ANN ARBOR HISTORIC DISTRICT COMMISSION

Staff Report

ADDRESS: 808 W Washington Street Application Number: HDC24-0188

APPLICATION: The applicant seeks HDC approval to rebuild a non-historic mudroom on the rear of the house in a footprint that is 24 square feet larger; construct a 23-foot-wide shed dormer on the south roof surface; and construct a 27'2" x 27'7" garage with a second floor accessory dwelling unit (ADU).

GARAGE
ELEVATIONS
and
SECTION

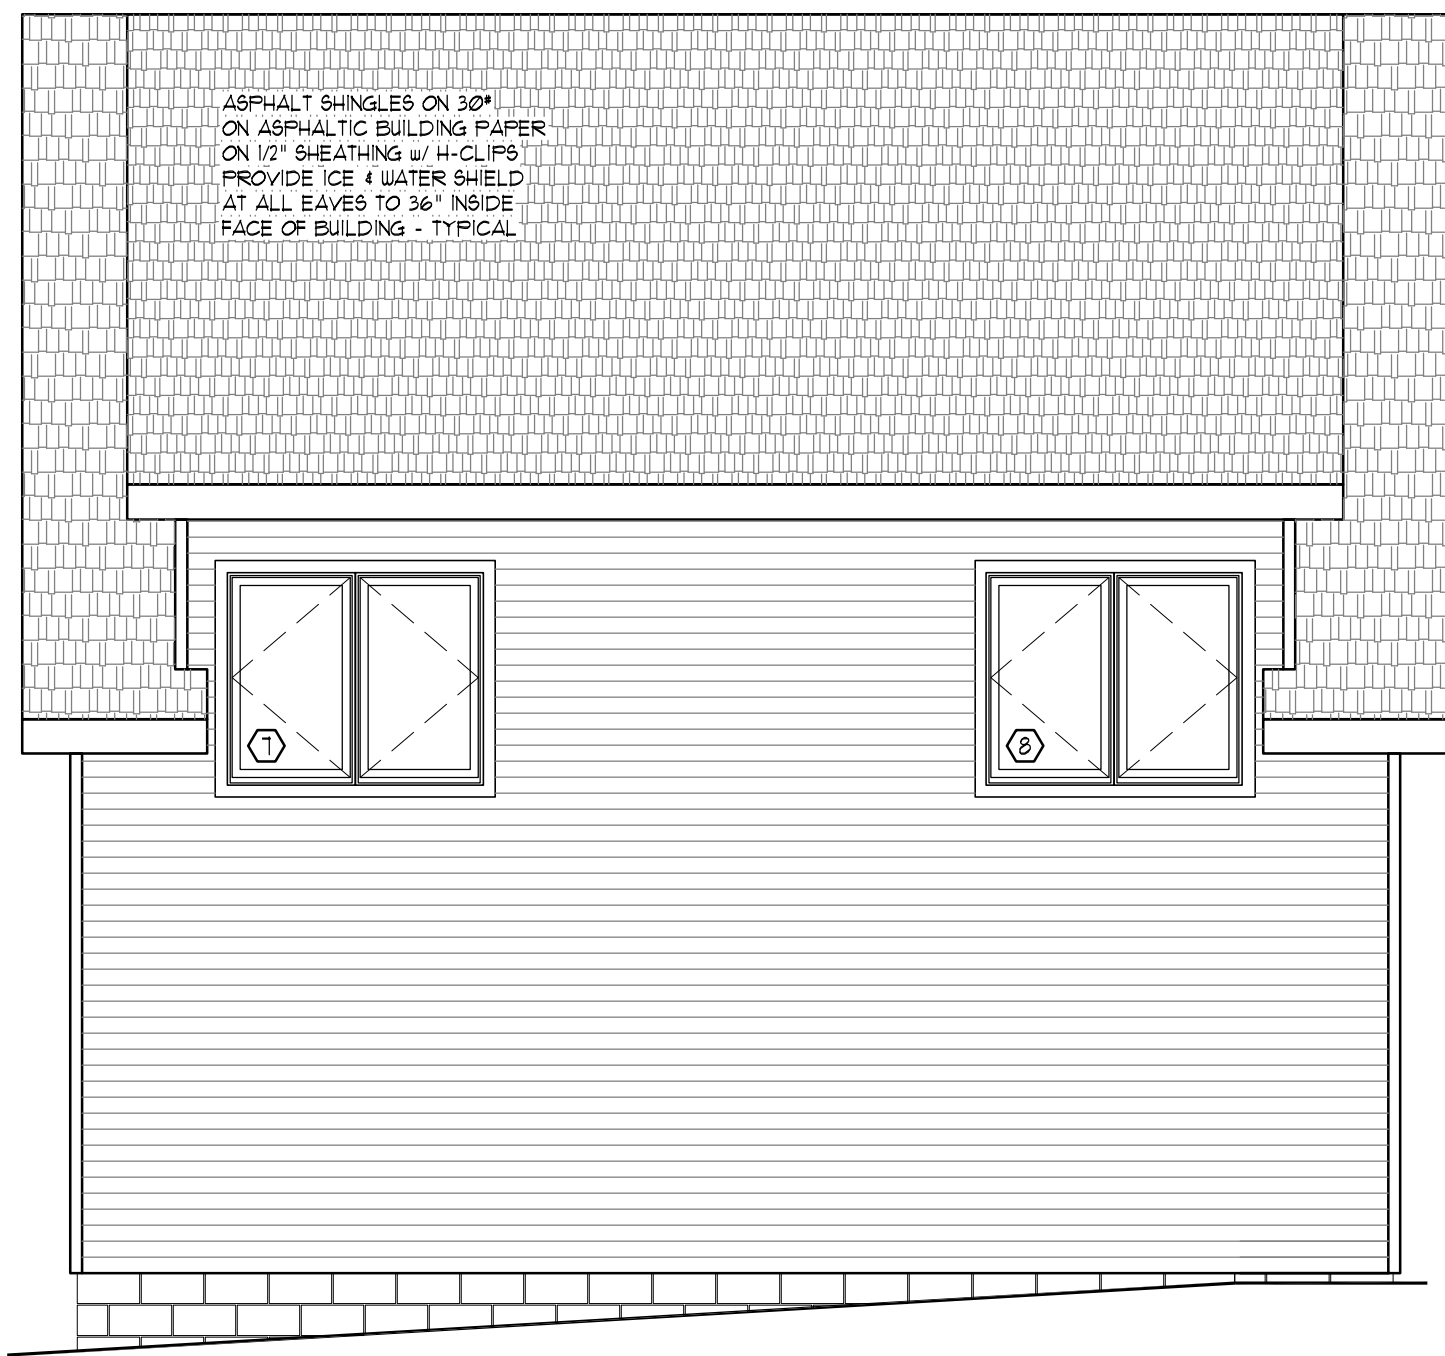
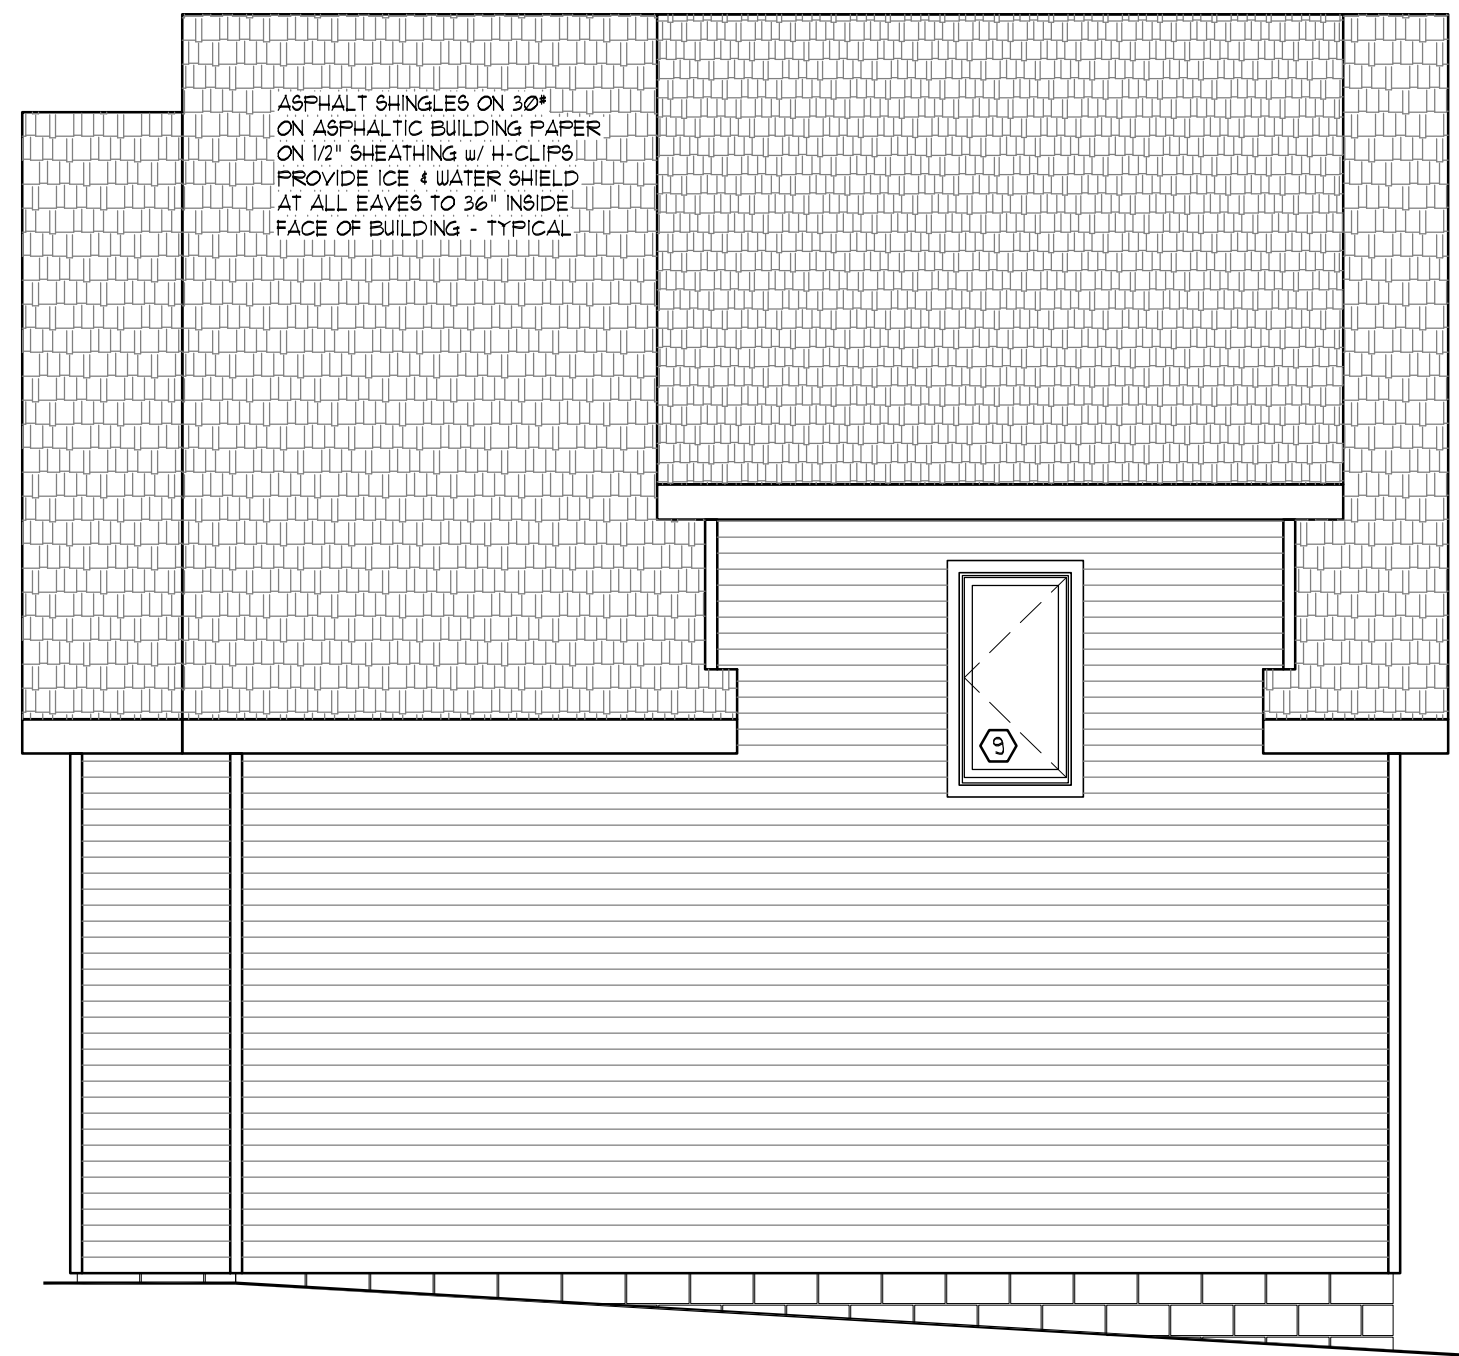
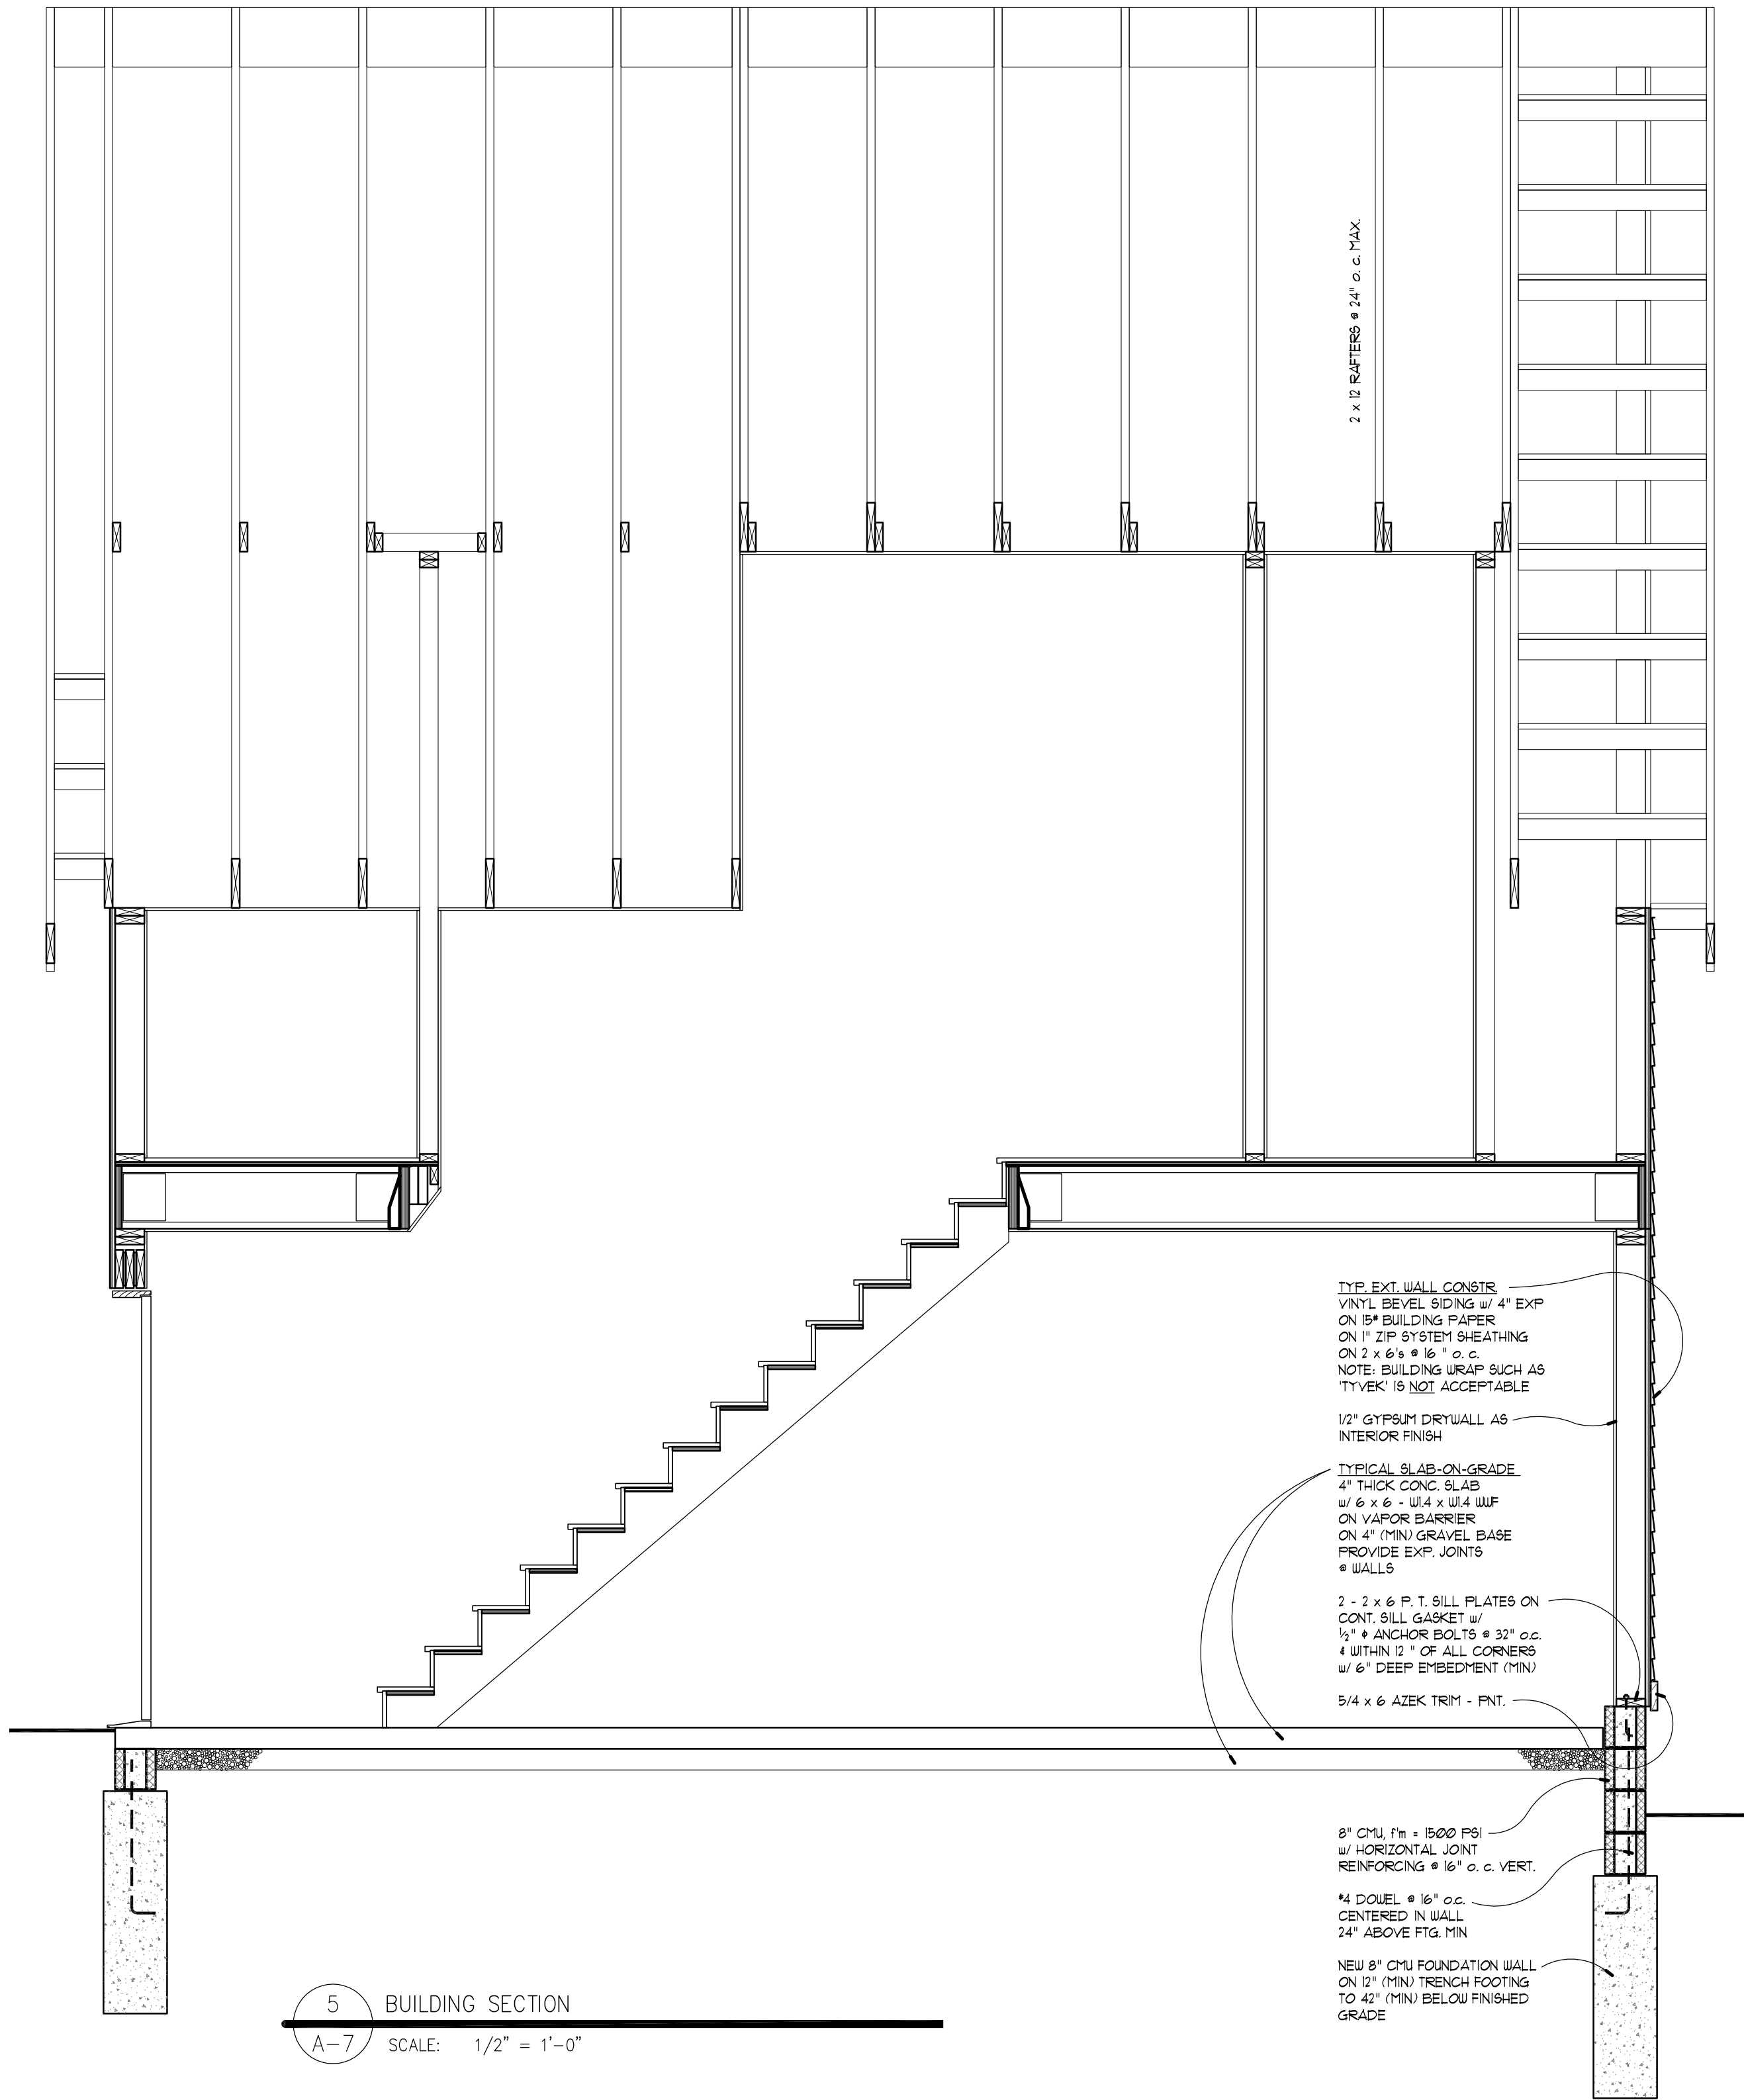
8. The garage has a 736 square foot footprint, with an accessory dwelling unit of the same size upstairs, for a total of 1472 square feet. This is very large for an accessory structure, though staff believes it is compatible with other garages and a large barn in the vicinity. The building is 1 3/4 stories with a ridge height of 26' 3". The zoning maximum height of 21' to the midpoint of the gable is not labeled, but this appears to comply. The foundation is slab on grade with concrete masonry unit trench footings. The garage has a two-car overhead door and a person door on the north elevation which accesses only stairs to the ADU. Materials for the overhead door and person door are not specified. This north elevation has two upper floor casement windows. The south elevation facing the house has a triple awning window and shed dormers on each side with single or paired

casement windows. Cladding is vinyl bevel siding with 4" exposure. The roof slope isn't specified, so it is unknown whether the pitch matches that of the house.
